Access Compliance Report

(Curb Ramps)

Intersection ID: 11566	Main Street: GRANDIN_RD	Cross Street: LITAKER_AV	Location: NW
ADA ID: 5333CA0501CE	Ramp Type: Perp	Initial Pass/Fail: Fail	Overall Compliance: No
		Severity Score: 12.5	
Codes/Mitigation Info/Possible Solution		Field Measurements/Component Compliance

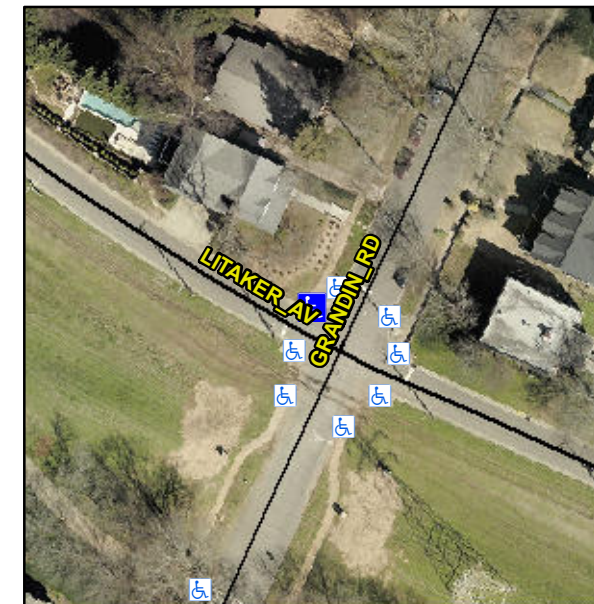
Not Found, R304.2.2

Compliance	Description	Data	Compliance	Description	Data
N/A	Ramp Length (in)	75.0	No	Ramp Slope (%)	9.1
Yes	Ramp Width (in)	48.0	Yes	Ramp XSlope (%)	0.8
N/A	Flare Type LT	N/A	N/A	Flare Type RT	N/A
N/A	Flare Slope LT (%)	N/A	N/A	Flare Slope RT (%)	N/A
N/A	Flare Traversable LT?	N/A	N/A	Flare Traversable RT?	N/A
N/A	Landing Length (in)	N/A	N/A	DWS Provided?	N/A
N/A	Landing Width (in)	N/A	N/A	DWS Contrast?	N/A
N/A	Landing Slope (%)	N/A	N/A	DWS Length (in)	N/A
N/A	Landing X Slope (%)	N/A	N/A	DWS Full Width?	N/A
N/A	Landing Curb? (Y/N)	N/A	N/A	DWS Offset (in)	N/A
N/A	Shared Landing?	N/A			
N/A	Gutter Ponding?	N/A	N/A	Gutter Slope (%)	N/A
N/A	Gutter Lip Ht (in)	N/A	N/A	Gutter X Slope (%)	N/A
N/A	Painted X Walk1?	No	N/A	Painted X Walk2?	N/A
	X Walk 1 Direction	To S		X Walk 2 Direction	N/A
N/A	X Walk 1 Width (in)	N/A	N/A	X Walk 2 Width (in)	N/A
	X Walk 1 Slope (%)	1.4		X Walk 2 Slope (%)	N/A
	X Walk 1 X Slope (%)	0.6		X Walk 2 X Slope (%)	N/A

Remove & Replace Entire Ramp.
